In the drawings

In the current Office Action, the drawings were objected to as failing to comply with 37 CFR 1.84(p)(5) because they do not include the reference signs for reference numbers 30 and 32. In response, Applicants herewith submit formal drawings having amendments that comply with the 37 CFR 1.84 rules. The reference numbers and drawing details were omitted in the originally filed application by typographical error. However, the current amendments correcting these drawing are completely supported by the description provided in the specification as originally filed. Therefore, the amendments to the drawings do not constitute new matter.

Fig. 3

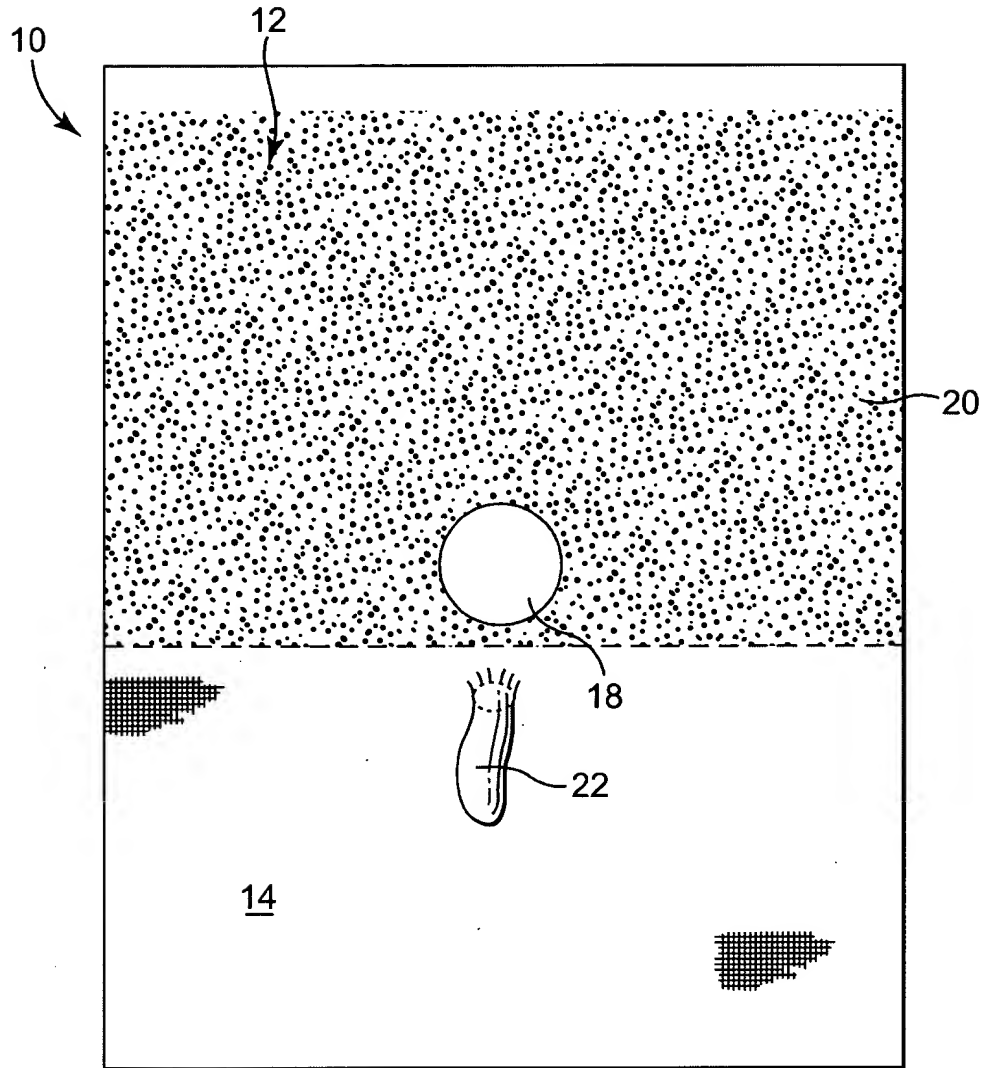
A location for the adhesive tabs 32 at figure 3 is explicitly described at page 7, paragraph 28. Amended figure 3 reflects that the adhesive tabs 32 can be positioned, for example, to secure the bottom of the drape to other structures.

In addition, the location of adhesive backing 20 has been included in amended figure 3, showing that the adhesive backing covers the patient side 14 from about the level of the pouch 24 to the top of the patient side 14, which is explicitly described in paragraph 27, page 6.

Fig. 2

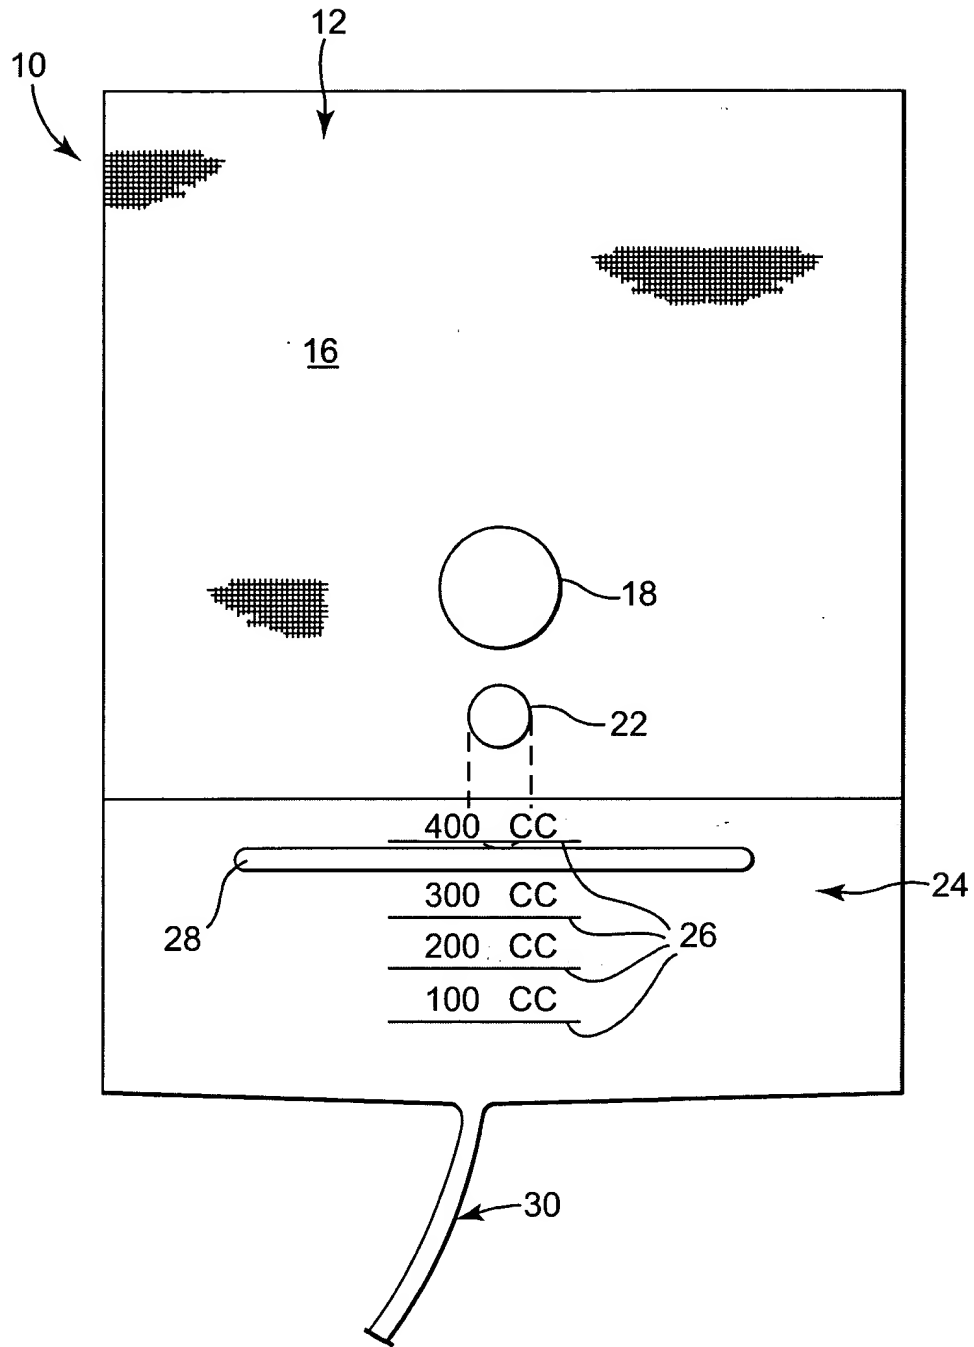
A location for the drain port 30, at figure 2, is explicitly described in page 6, paragraph 26. Amended figure 2 reflects that the drain port 30 is in fluid communication with the pouch, as recited in the specification.
